Construction Division
Additions & Alteration Charges Approval Form

Details of Additions & Alterations

Flat No	304	Block no.	'A'
Flat Area	1500 sft	Type	Deluxe / Luxury
Buyer Name	Mr. Peruri Suryanarayana Rao		
Phone No.	8099428026/ 9440027911c	Email	suneelaperuri@phoo.com

Description		Direction	Owners & Developers :		Date :	Promoted by
WORKING DRAWING OF FLAT.NO. A-4			Modi Properties Pvt Ltd.		Prepared By :	Modi Properties Pvt. Ltd
			Project Name & Phase :		Approved By :	
			MAYFLOWR PLATINUM		S : P :	
					Approved By : Soham Modi	Phone: +91-40-66335551
					N.T.S

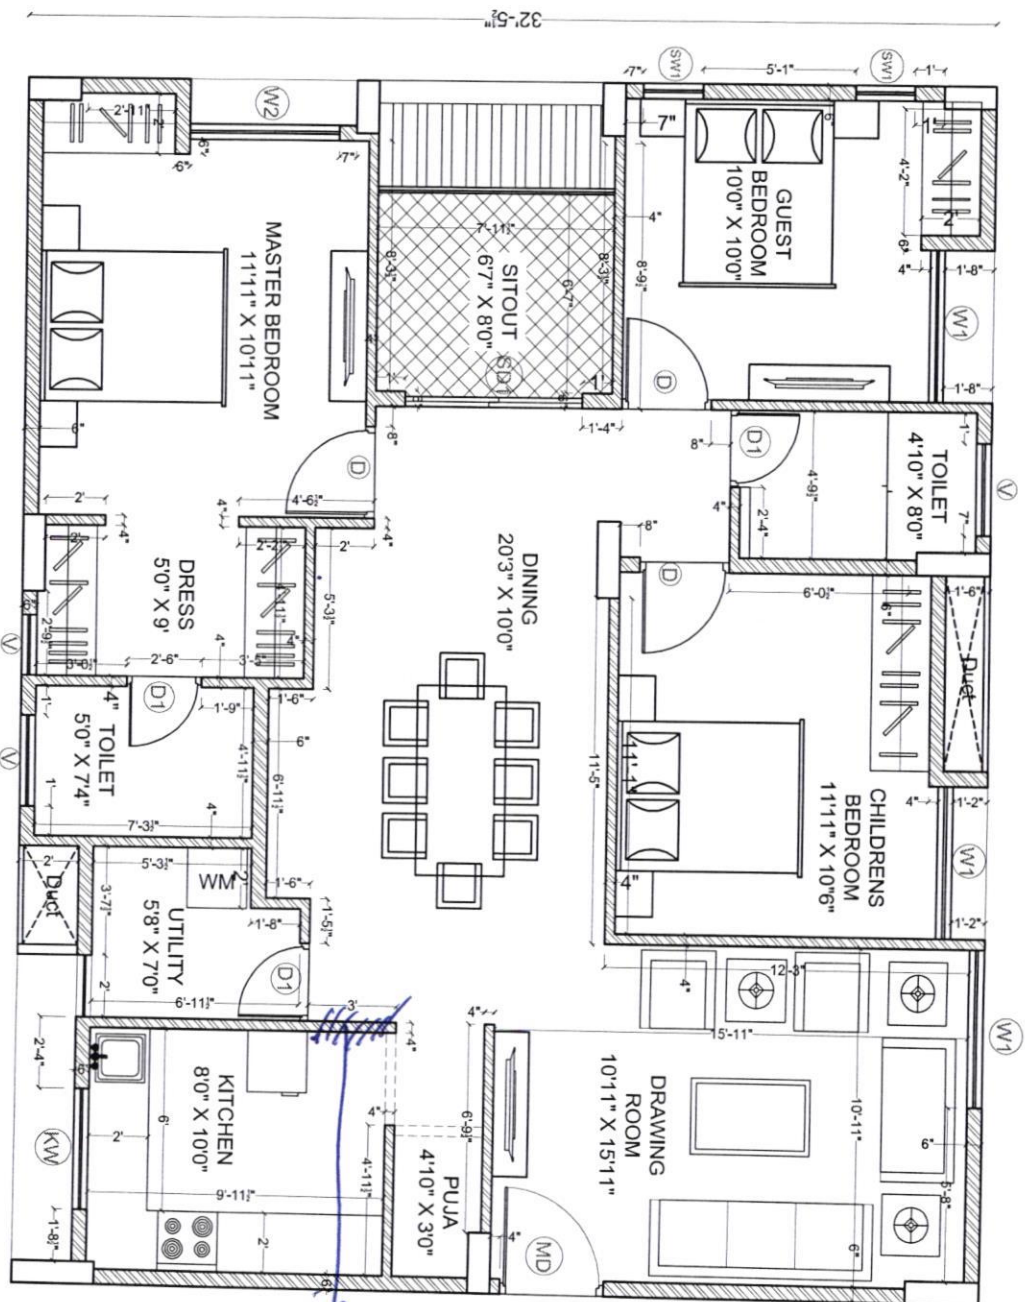
Changes in kitchen platform: (mark on plan)

① Marked on plan

② Kitchen platform height should be 2" (34") as customer to be asked.

Other Changes: ① False ceiling by customer
② All window - 3 doors

To be removed

ELECTRICAL PLAN OF FLAT-A4

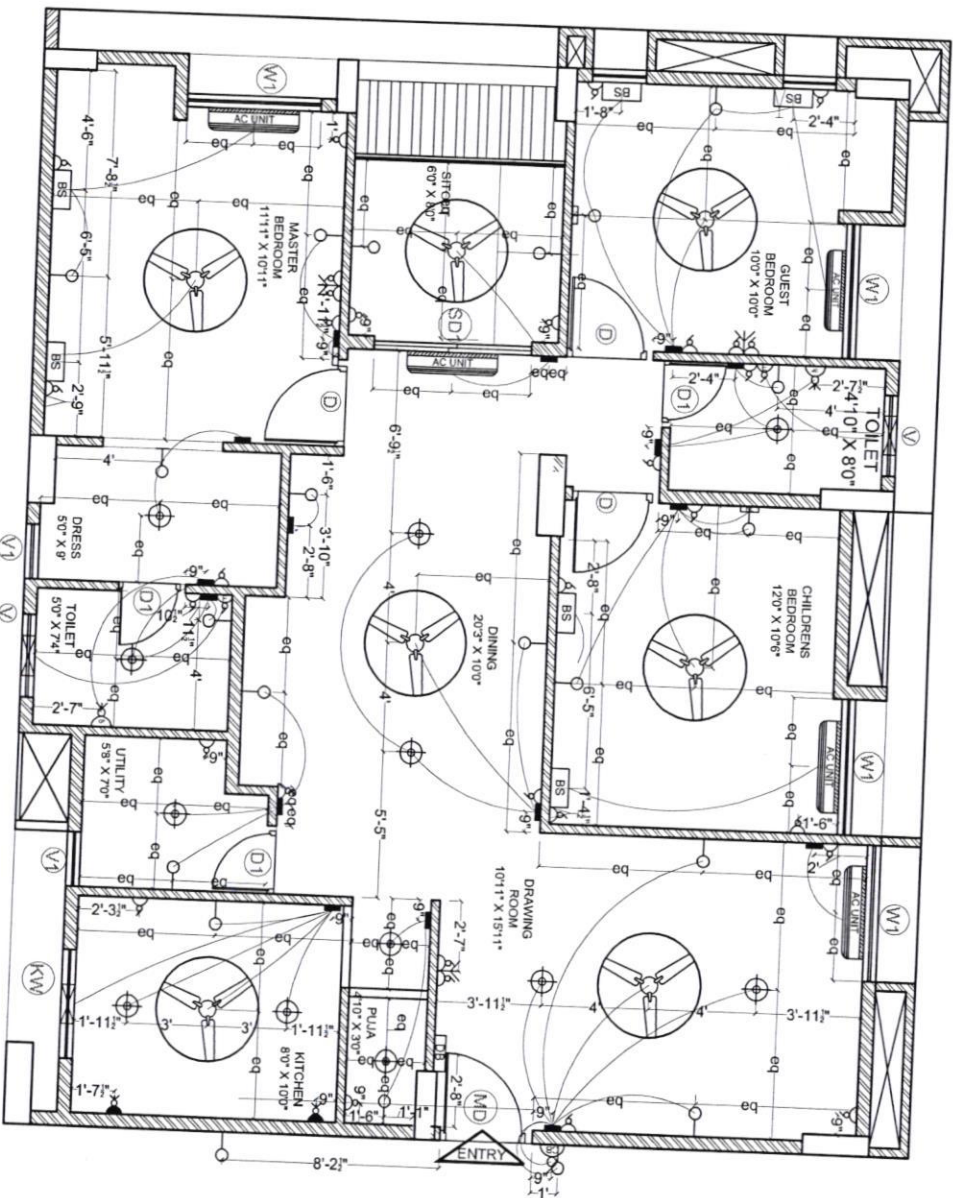
Changes in electrical points: (mark on plan) ① No changes
